Project: **La Jara Dental Clinic – Addition & Remodel** Project No.: 2614

Addendum No.: **02**

Date: **09/14/2026**

SHEET #:

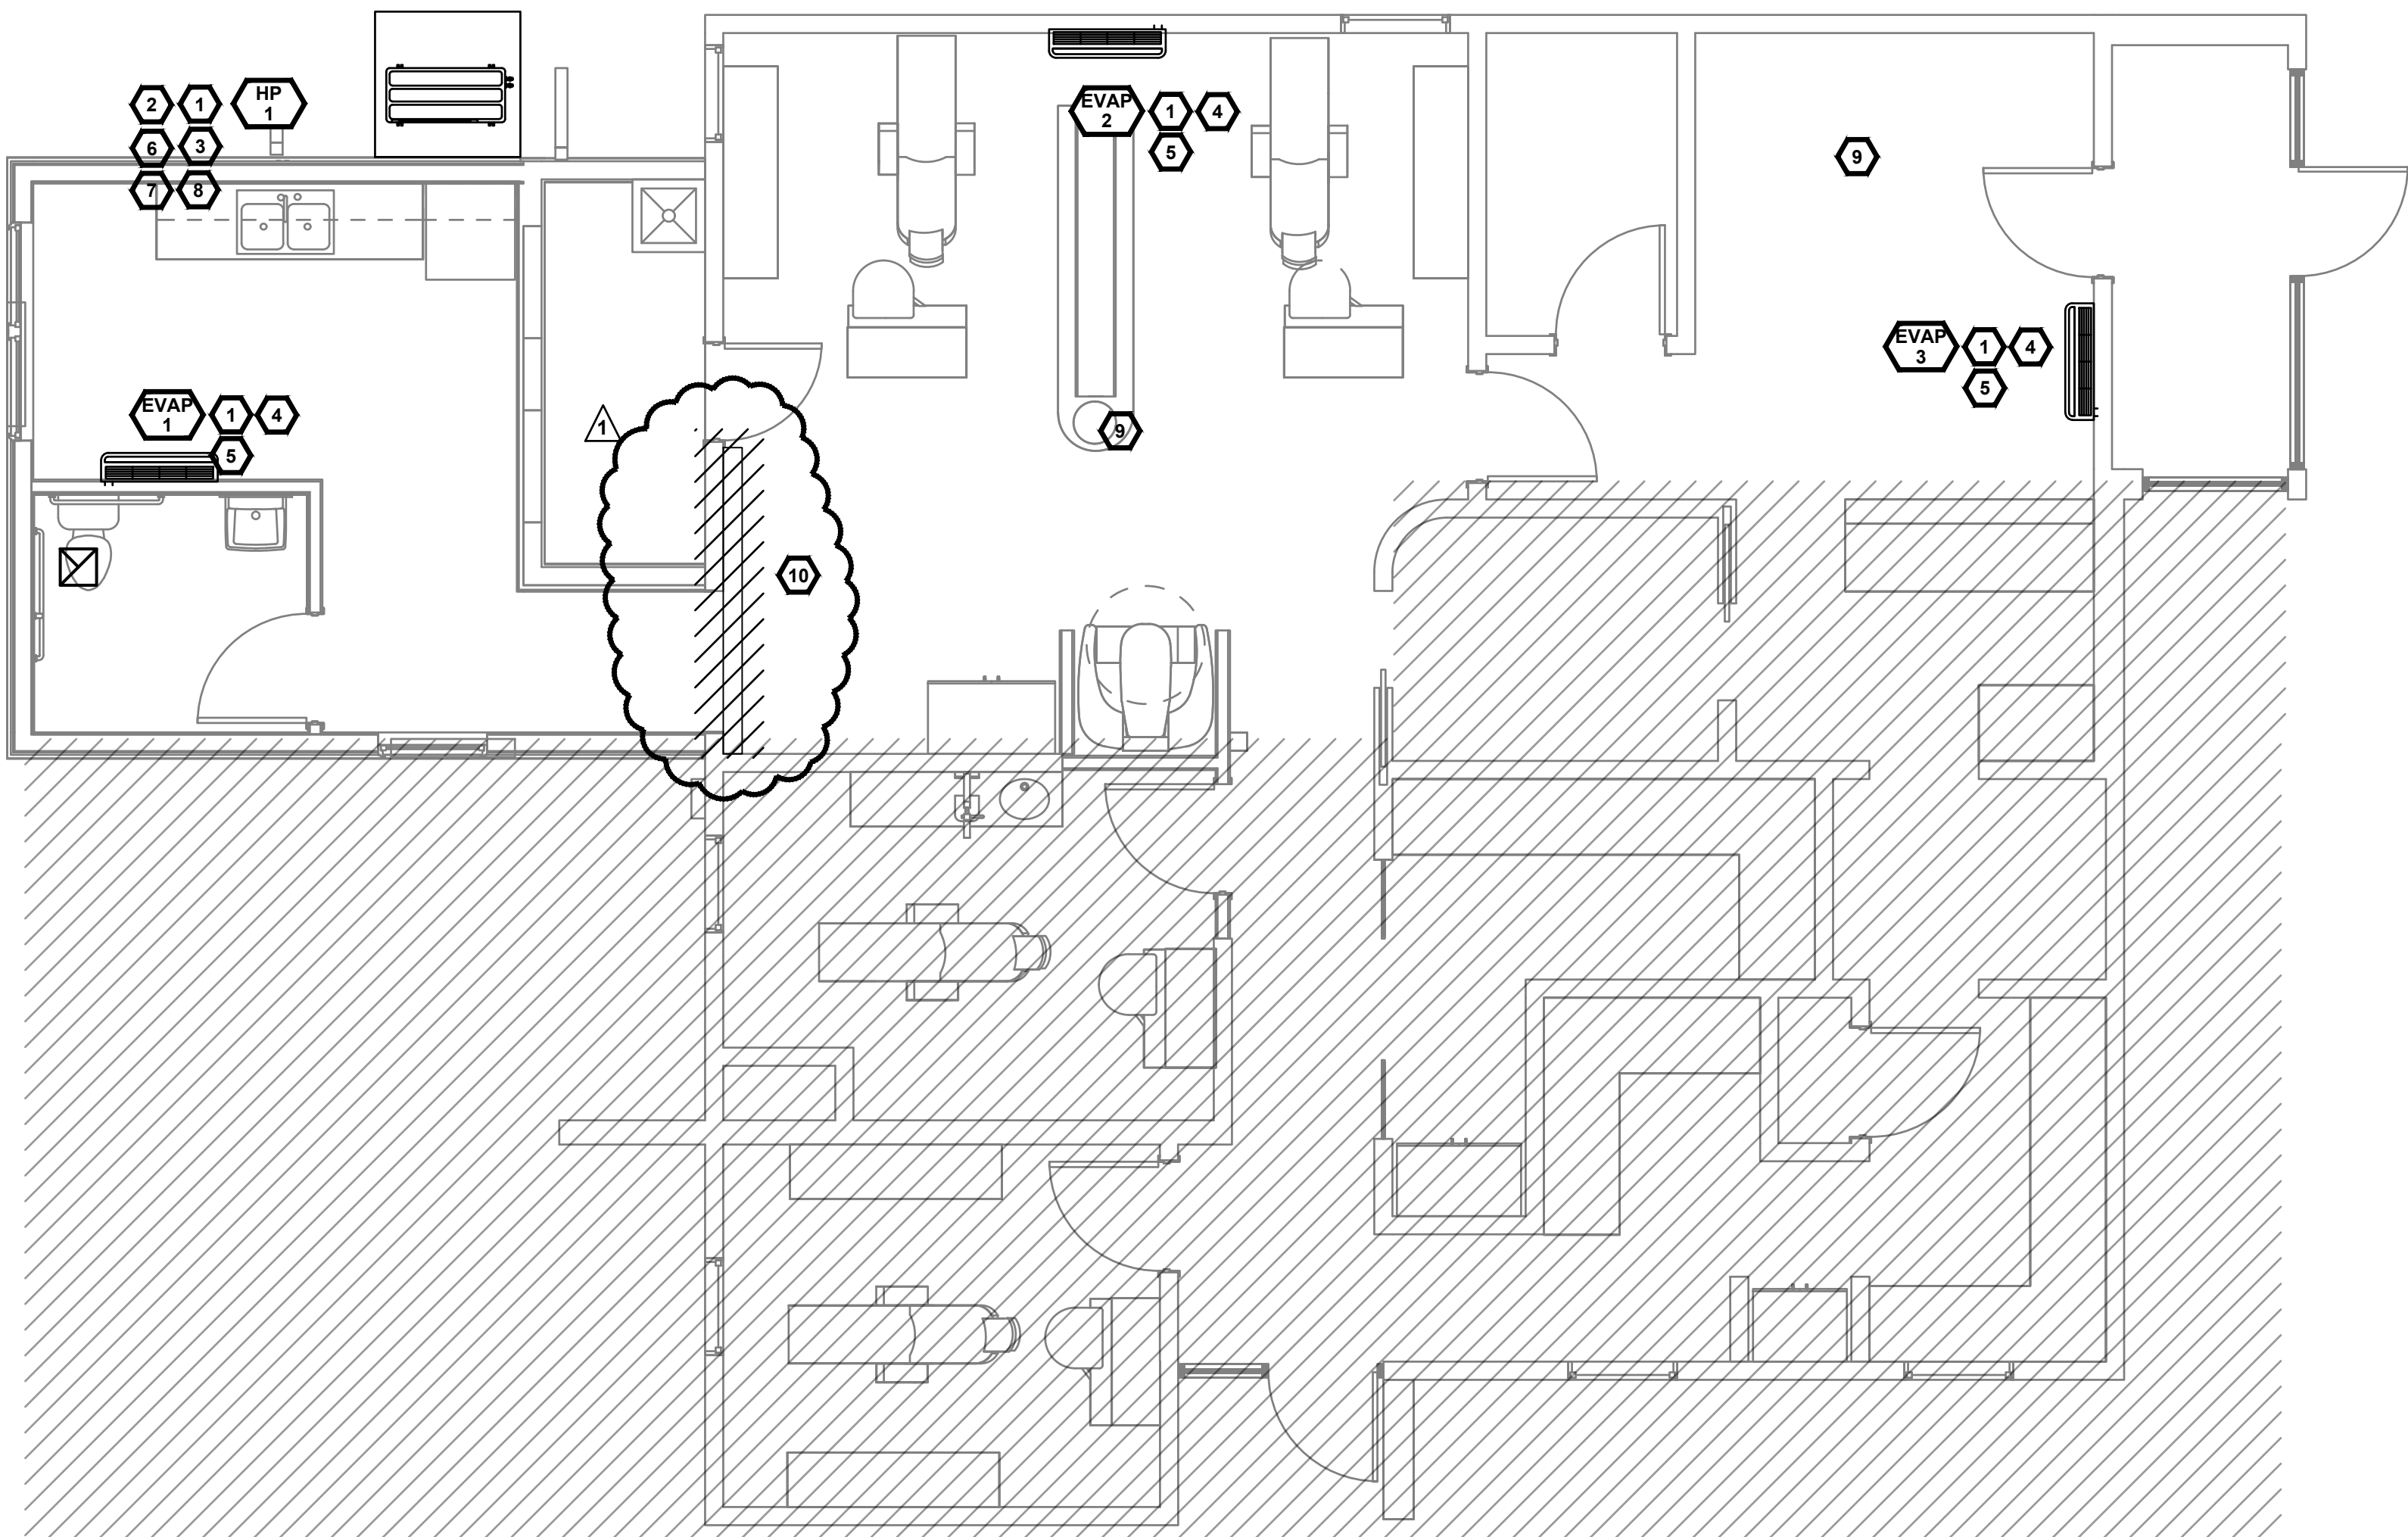
- a. T-001: Include \$5,000 allowance noted above. This requirement has been added to cover sheet.
- b. AD-101 & A-101 & M-111: Scope added to demo work on West wall. Contractor is responsible for removing baseboard heater and wire mold along this wall. If wire mold is in use, reroute wire and new wire mold up over new hallway opening.
- c. AD101 & A-101: Existing access to crawl space needs to move. Remove existing panel and infill per A-101. New access will be in office 106. Confirm exact location with owner on site. Flooring and sub flooring to be demoed for new access. Existing access panel to be reused.
- d. A-101: Carpet tile specification added.
- e. PD-111 & P-111: Remove and relocate existing cleanout as noted.
- f. ED-121 & E-121 & E-601: New electric service needed. Demo existing. Contractor to re-feed existing panel A from new service.

Sheet AD-101, Demolition Keynote D24, identifies two existing items to be removed and reused. Sheet A-101, Keynote 12.42, shows their proposed relocated positions. Both items appear to have the same footprint on the demolition plan, but one is shown with a reversed footprint on the proposed plan. Please clarify whether the existing item can be reused as shown or whether modification or replacement is required. **These 12'o'clock units are all identical – no modifications needed. (2) to remain in the open area and (1) moves into the Closed Op 115, positioned on East wall facing West.**

Sheet A-101, Interior Finish General Note 1, requires flooring to extend from partition to partition. Please confirm whether existing casework designated to remain in Open Dental 108 and Closed Op 117 must be removed and reinstalled to accommodate the new

22.01 ACCESSIBLE TOILET; SEE PLUMBING
22.02 ACCESSIBLE SINK; SEE PLUMBING
26.23 ELECTRICAL BOX TO REMAIN; SEE ELEC.
26.25 IF DEMOED WIRE MOLD WAS IN USE, REROUTE WIRE AND NEW WIRE MOLD UP AND OVER HALLWAY OPENING

flooring. Casework in Dental Op 108 (Casework C on plans) will move into Closed Op 115. Flooring in closed Op 117 can terminate at casework.

ED121

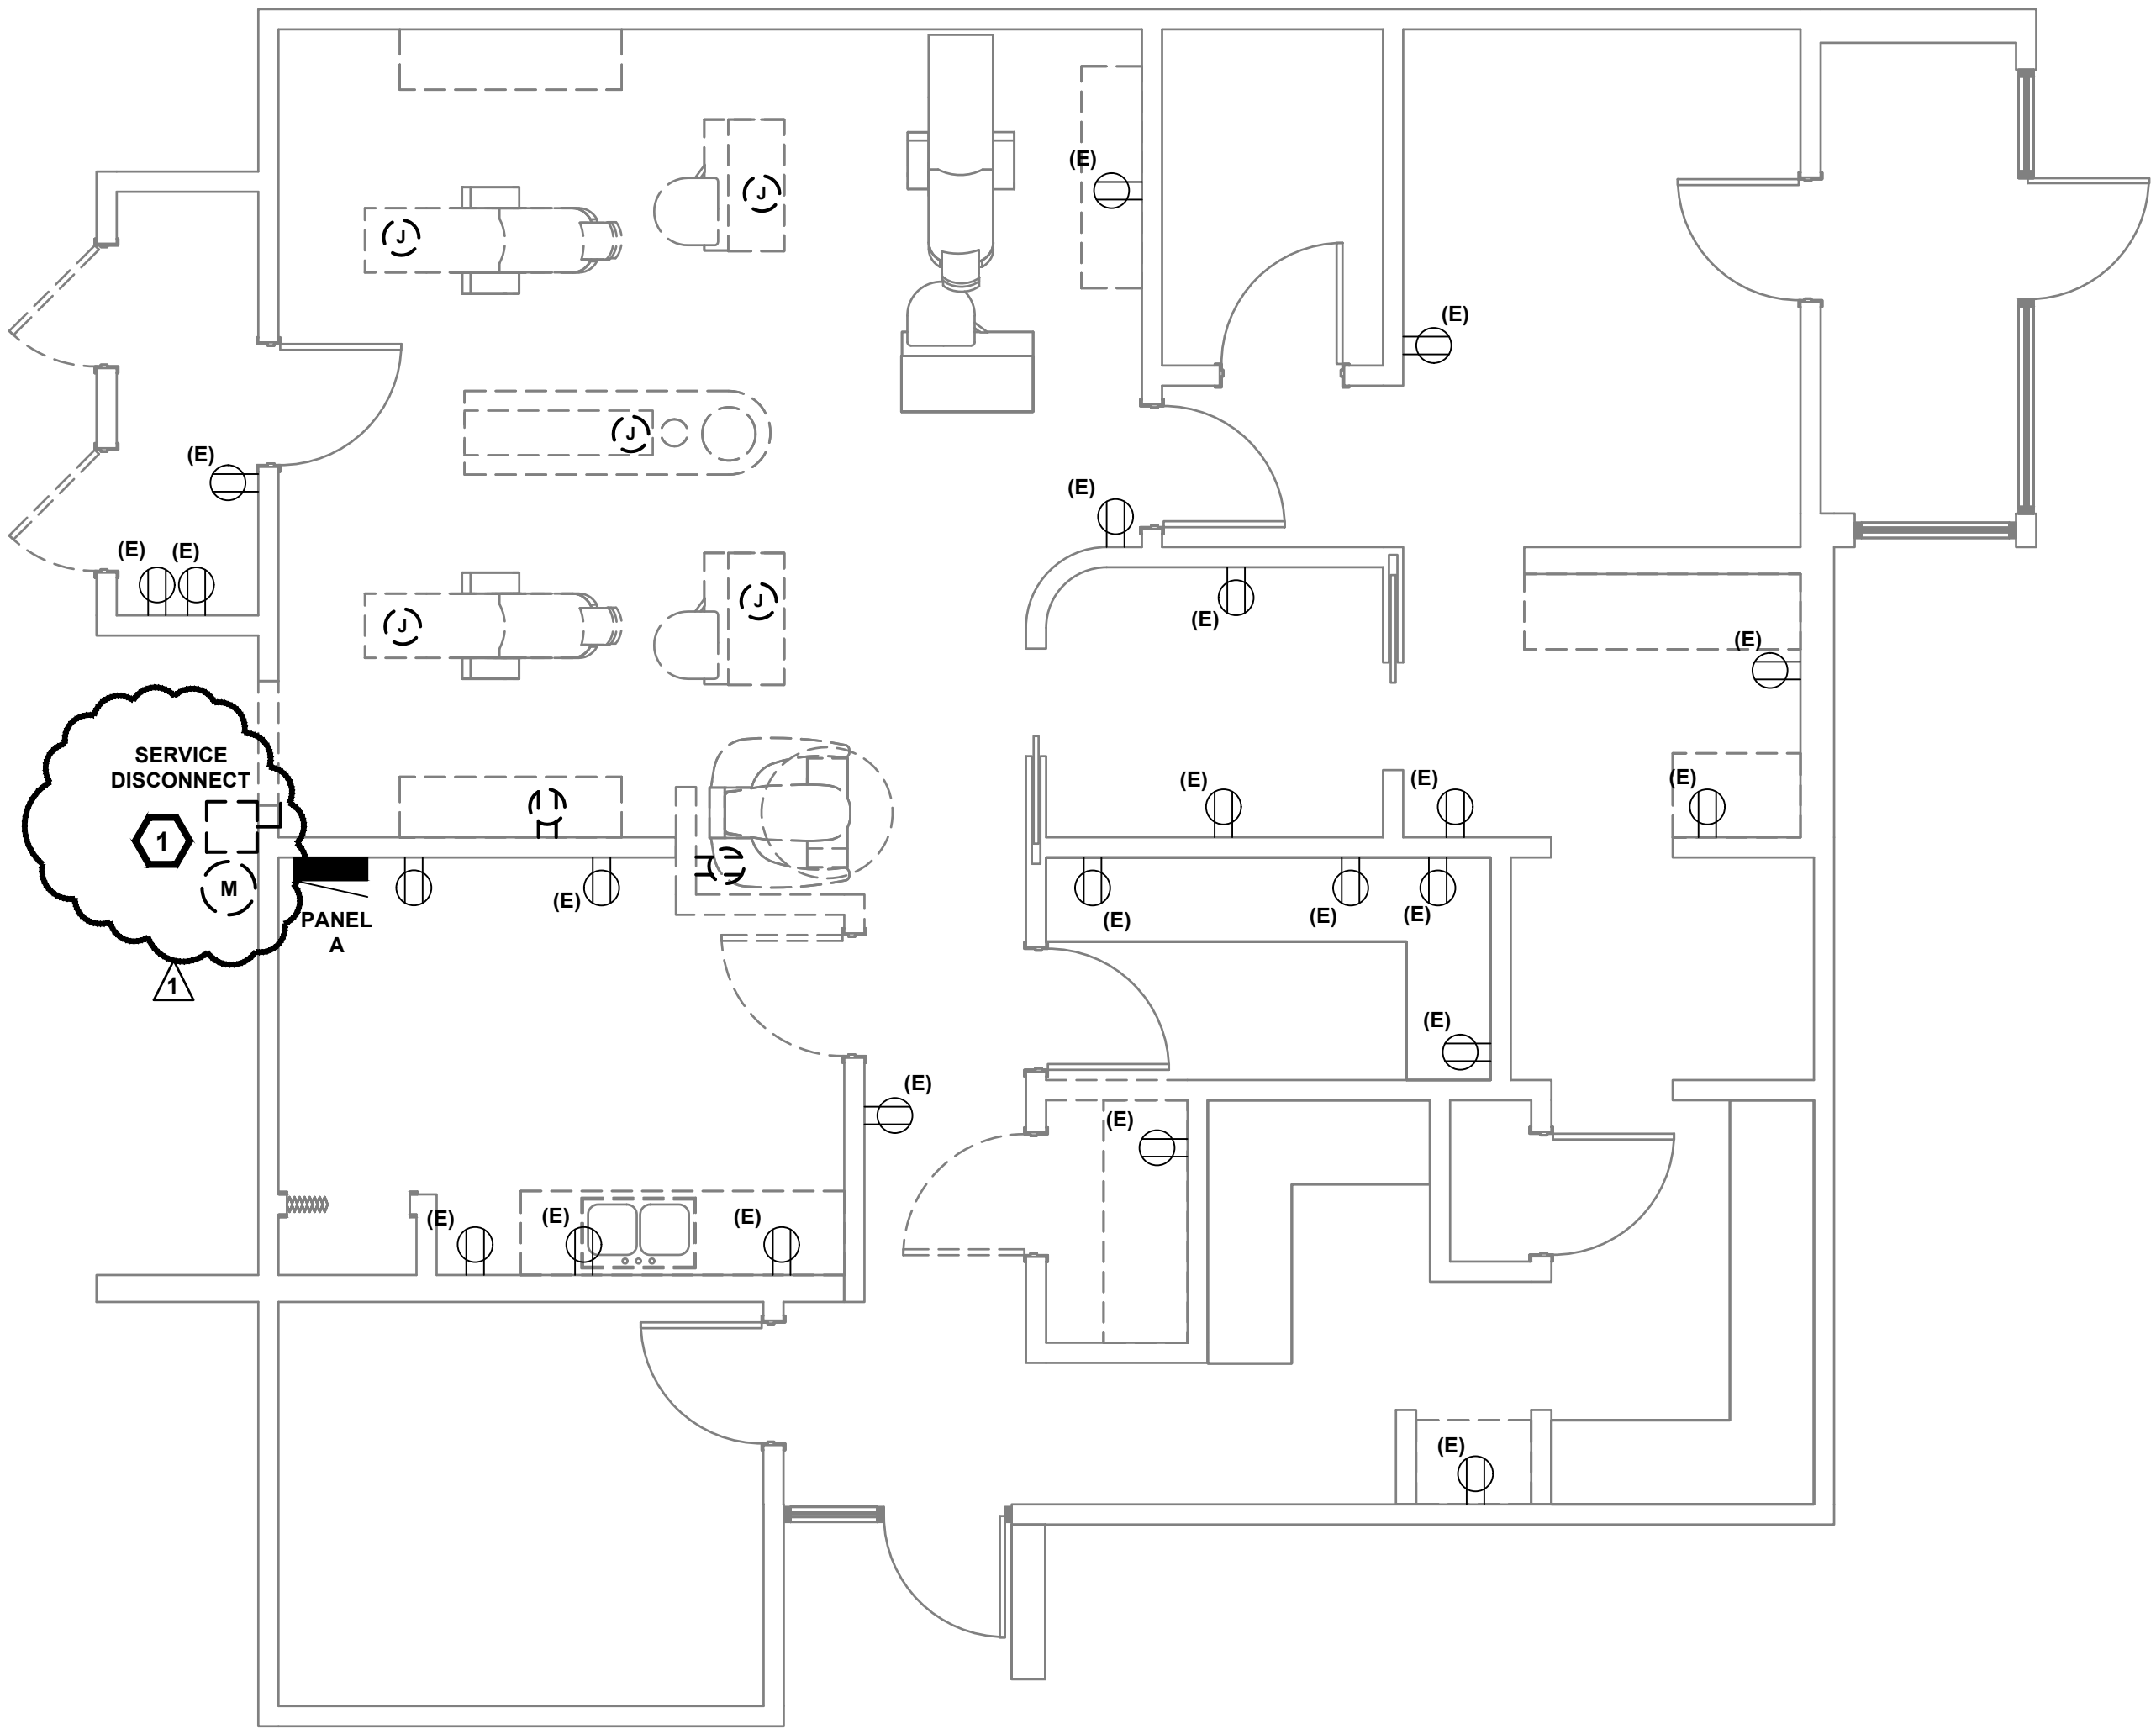
Sheet ED121 does not indicate removal or relocation of the existing baseboard heater at the proposed new door location. Please confirm whether the heater is to be removed or relocated. If relocation is required, please provide the new location and installation requirements. This is covered in Addendum #2, which will be distributed in the coming days. Wire molding and baseboard heater to be removed and re-used on north wall of Open Dental 109, if applicable. Scrapped if not applicable.

1 CONTRACTOR TO DEMO EXISTING SERVICE.
